S96 No: N0267/13/S96/2

N0267/13/S96/2 Modification of Development Consent N0267/13 for Demolition, earthworks and construction of a Seniors Housing Development pursuant to SEPP (HSPD) 2004 consisting of 59 self-contained dwellings with a community building, bowling green, landscaping and carparking at 6 MACPHERSON STREET WARRIEWOOD NSW 2102.

MODIFICATION OF DEVELOPMENT CONSENT NO: N0267/13

- ***Amended Hardscape Plans LP-1.2, LP-1.3, LP-1.4 and LP-1.5, prepared by John Lock and Associates, dated 22 October 2015;***

**STAGE 4, 5 and 6
 MACPHERSON STREET ENTRY
 HARDSCAPE PLAN**

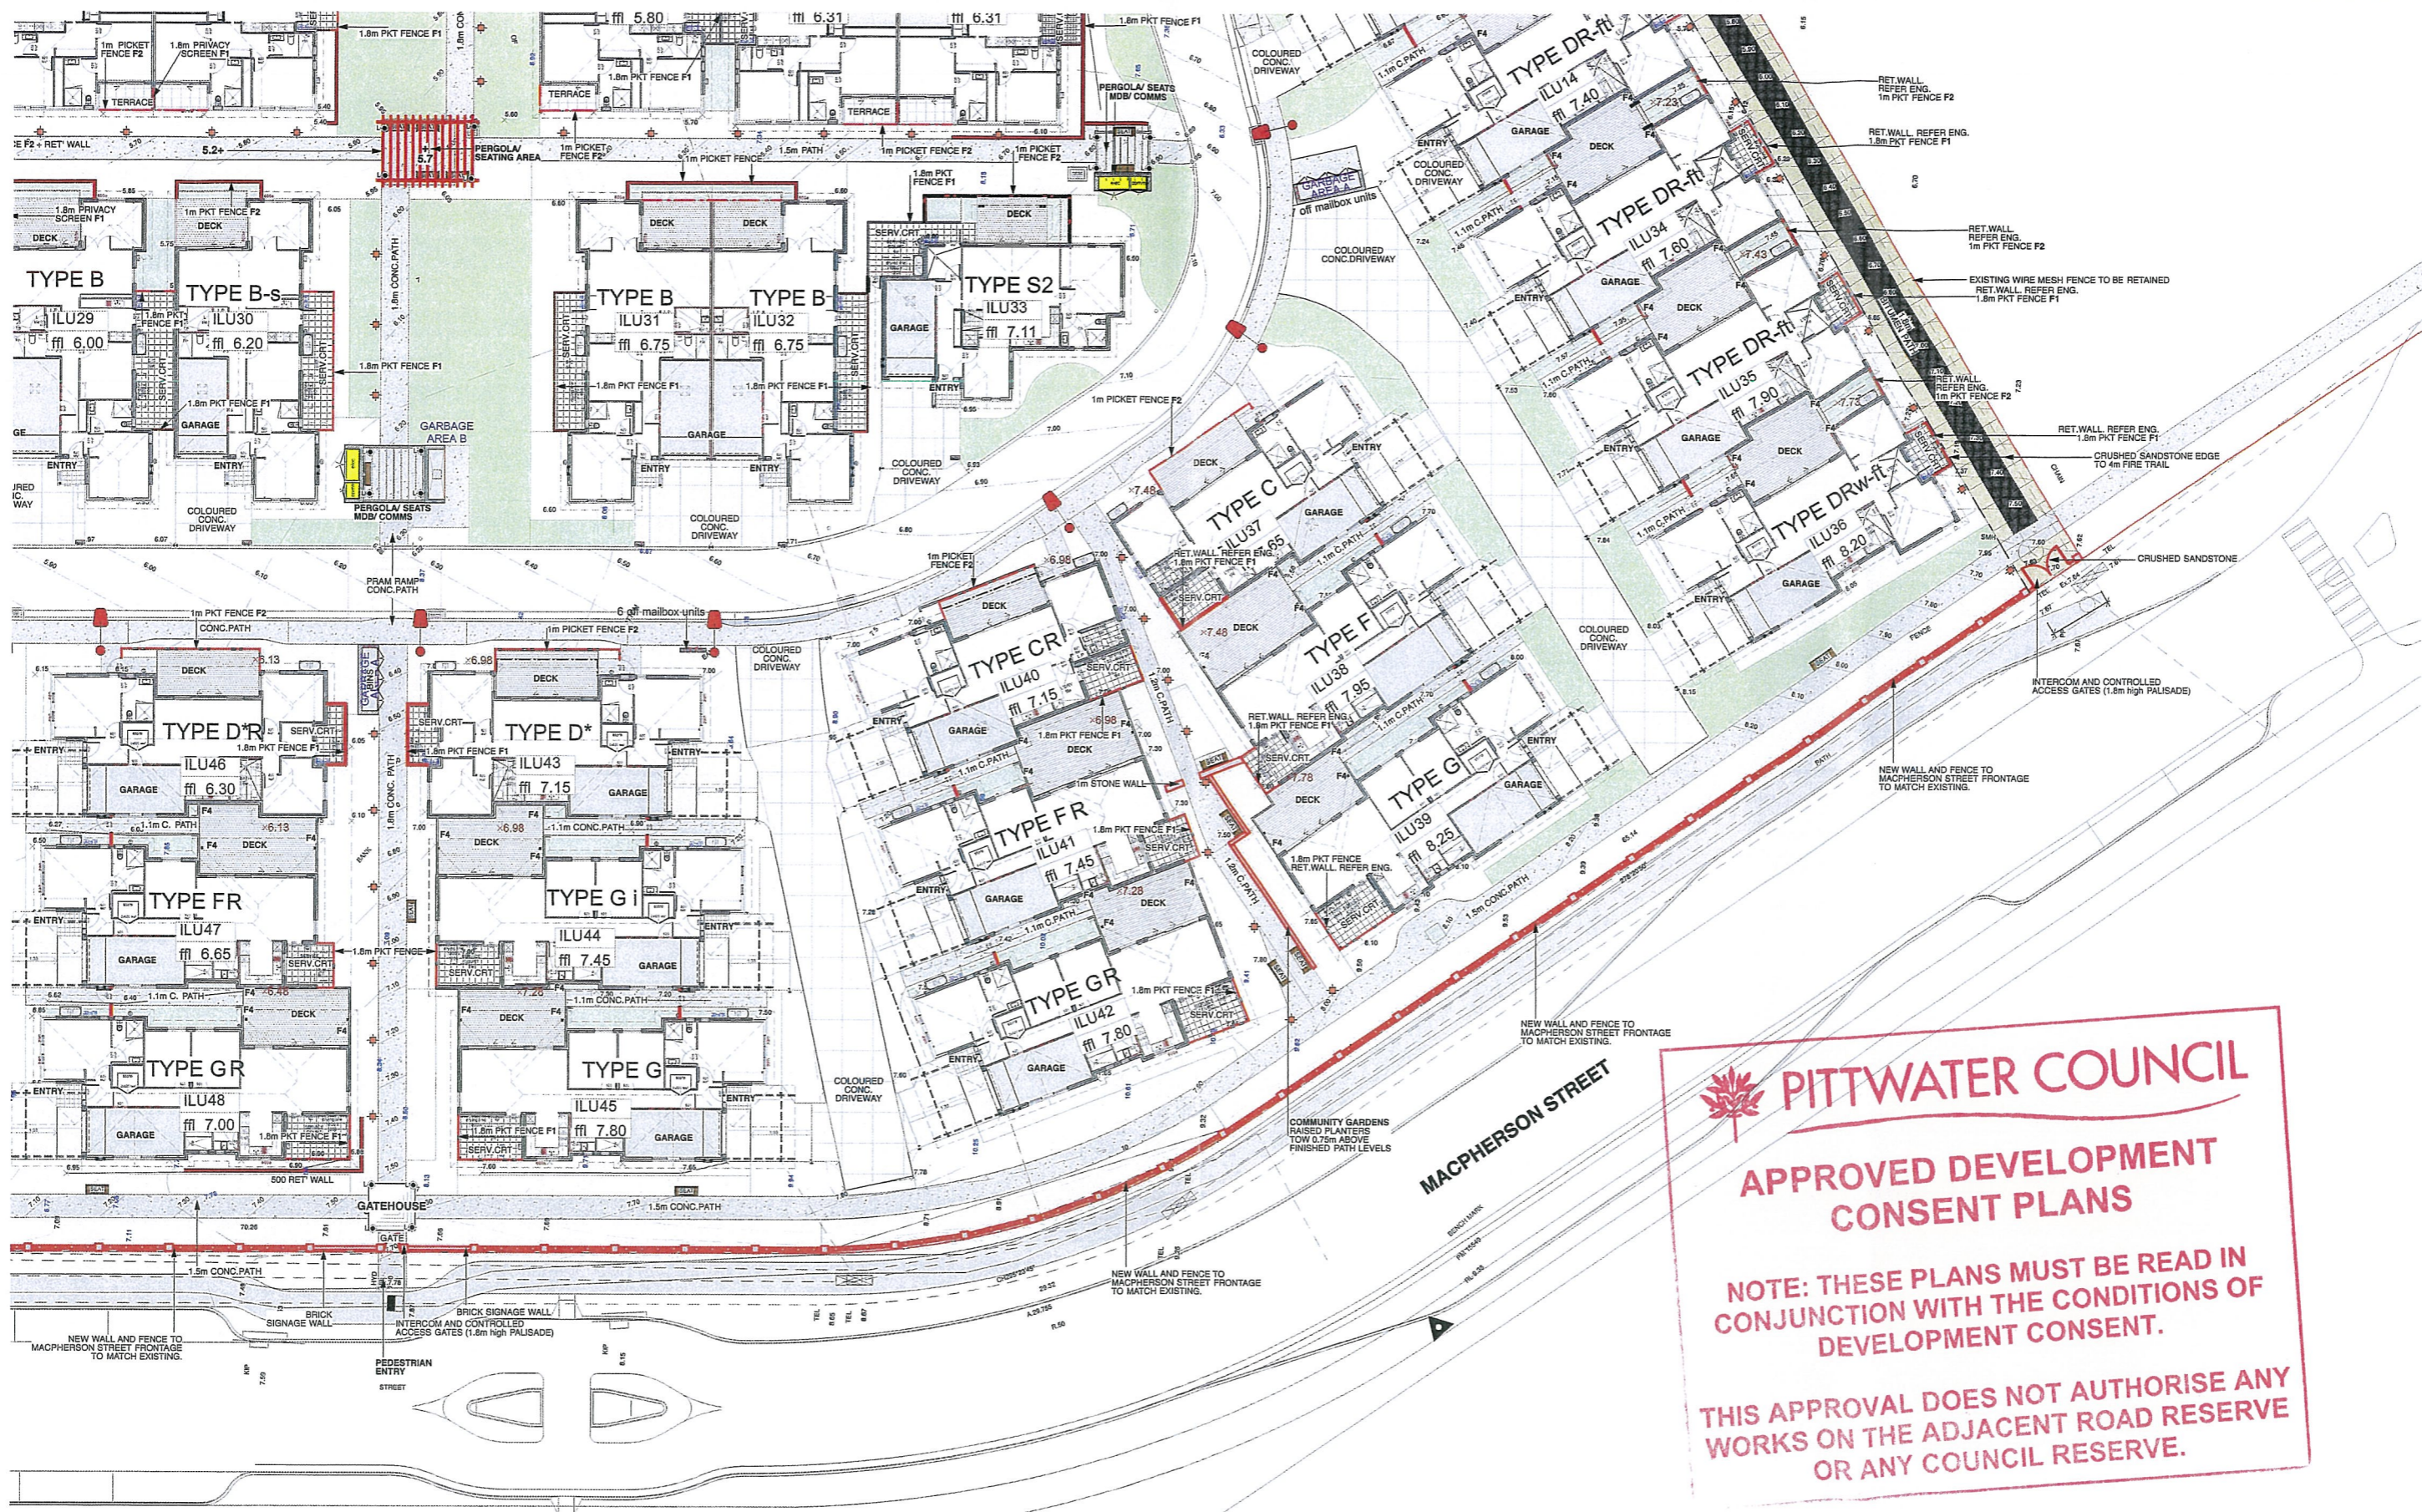
- **1.8m high picket fencing around the service courts as shown on the Amended Hardscape Plans referenced in this modified consent, in association with Dwellings 3-36, 43, 46, 49, 56, 57, 58, and 59 only;**

- **1m high picket fencing around the deck areas as shown on the Amended Hardscape Plans referenced in this modified consent, in association with Dwellings 5, 7, 15-23, 37, 40, 43, 46, 49, and 52 only;**

- 35. The Amended Hardscape Plans referenced in this modified consent (N0267/13/S96/2) relate solely to the incorporation of fencing around decks and service courts of certain dwellings. No other changes within these drawings are authorised by this consent. In particular, no additional hard surfaces are authorised by this modification application, and the resultant landscaped areas must be strictly in accordance with the Landscape Plans referenced in this consent (Landscape plans LP-1.0, LP-1.1, LP-1.2, LP-1.3, LP-1.4, LP-1.5, LP-1.6, LP-1.7, LP-1.8, LP-1.9, LP-2.0, LP-2.1, LP-3.0, LP-3.1, LP-3.2, LP-3.3, LP-3.4, all revision 03, prepared by John Lock & Associates Landscape Architecture, dated 19 November 2013).**
